# Access Compliance Report

## Public Rights-of-Way

Intersection ID: 48713	Main Street: ROLLING_CREEK_CT	Cross Street: KILCULLEN_DR	Location:	N
ADA ID: A536FA58D4AF	Ramp Type: PerpDiag	Initial Pass/Fail: Fail	Overall Compliance: No	Severity Score: 22.5
Codes/Mitigation Info/Possible Solution		Field Measurements/Component Compliance

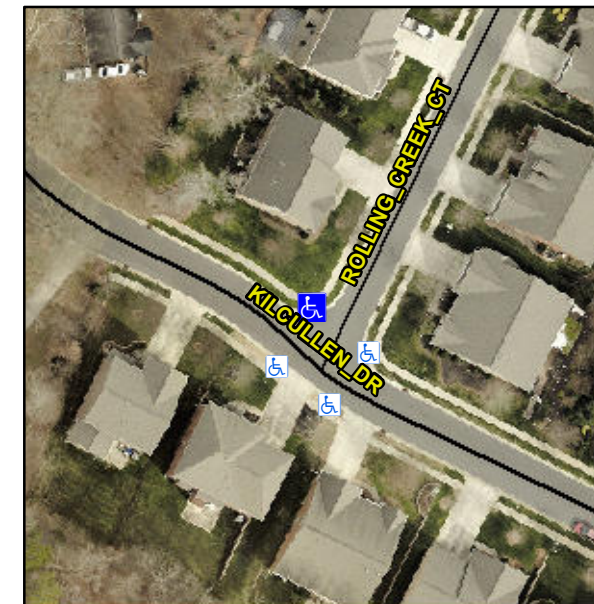
**R304.5.1, R304.2.2, R304.5.3**

Compliance	Description	Data	Compliance	Description	Data
N/A	Ramp Length (in)	48.0	No	Ramp Slope (%)	8.8
No	Ramp Width (in)	46.0	No	Ramp XSlope (%)	4.4
N/A	Flare Type LT	N/A	N/A	Flare Type RT	N/A
N/A	Flare Slope LT (%)	N/A	N/A	Flare Slope RT (%)	N/A
N/A	Flare Traversable LT?	N/A	N/A	Flare Traversable RT?	N/A
N/A	Landing Length (in)	N/A	N/A	DWS Provided?	N/A
N/A	Landing Width (in)	N/A	N/A	DWS Contrast?	N/A
N/A	Landing Slope (%)	N/A	N/A	DWS Length (in)	N/A
N/A	Landing X Slope (%)	N/A	N/A	DWS Full Width?	N/A
N/A	Landing Curb? (Y/N)	N/A	N/A	DWS Offset (in)	N/A
N/A	Shared Landing?	N/A			
N/A	Gutter Ponding?	N/A	N/A	Gutter Slope (%)	N/A
N/A	Gutter Lip Ht (in)	N/A	N/A	Gutter X Slope (%)	N/A
N/A	Painted X Walk1?	No	N/A	Painted X Walk2?	No
	X Walk 1 Direction	To SW		X Walk 2 Direction	To SE
N/A	X Walk 1 Width (in)	N/A	N/A	X Walk 2 Width (in)	N/A
	X Walk 1 Slope (%)	0.3		X Walk 2 Slope (%)	4.5
	X Walk 1 X Slope (%)	5.5		X Walk 2 X Slope (%)	0.8

**Remove & Replace Curb Ramp With Two New Directional Ramps or Equivalent.**
